# CITY OF ALBUQUERQUE

**RE: Lot 11 Block 4 Volcano Cliffs Unit 18 SAD 228  
6615 Cuervo Pl. NW  
Grading and Drainage Plan  
Engineers Stamp Date 1/14/20 (D10D003J11)  
Pad Certification Date 3/27/20**

ENGINEER'S SEAL  1/14/20	LOT 11 BLK 4 U 18 VOLCANO CLIFFS 6615 CUERVO PLACE  GRADING AND DRAINAGE PLAN   1608 CENTRAL AVENUE SE SUITE 201 ALBUQUERQUE, NM 87106 (505) 972-0899	DRAWN BY DEM
		DATE 1-14-20
DAVID SOULE P.E. #14522	LOT 11 BLK 4 U 18 VOLCANO CLIFFS 6615 CUERVO PLACE DWG	SHEET # C1
		JOB #

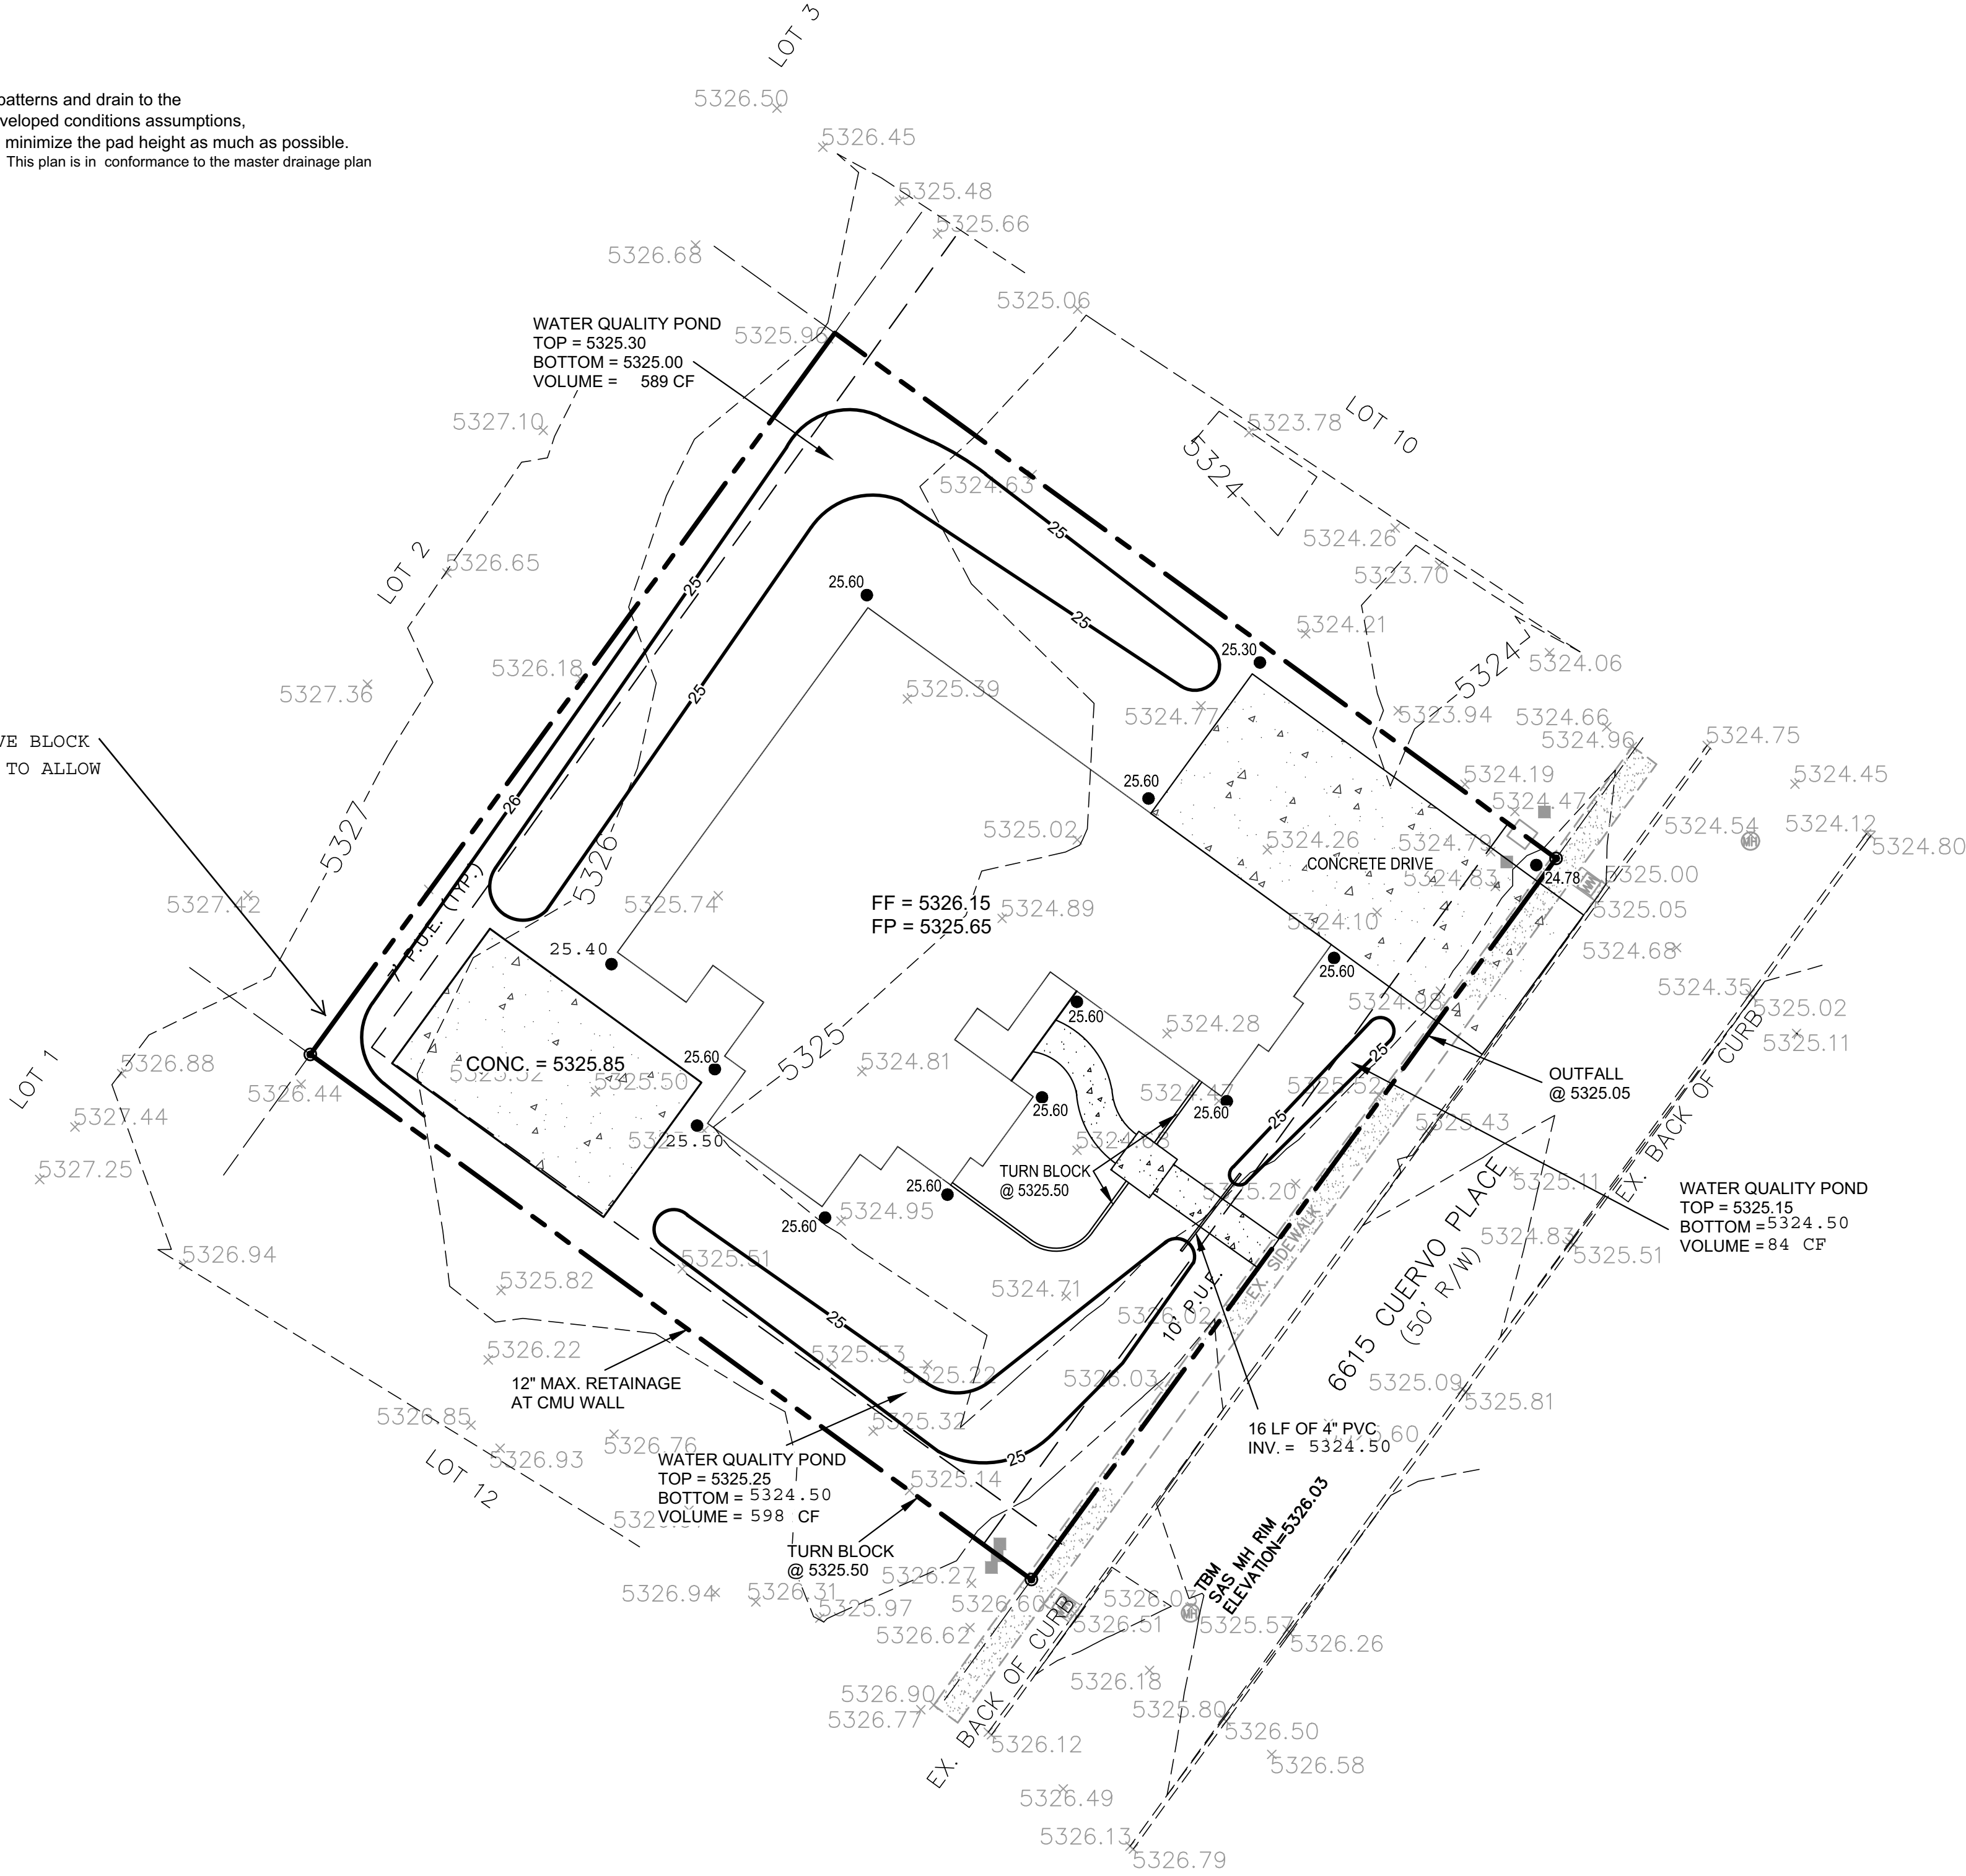
Based upon the information provided in your submittal received 3/31/20, this plan is approved for Building Permit.

**Reiterate to the Owner/Contractor that a separate permit for a garden/retaining wall must be obtained, with the approved G&D plan dated 1/14/20 and Pad Certification Date 3/27/20.**

Prior to Certificate of Occupancy release, Engineer Certification per the DPM checklist of this plan will be required.
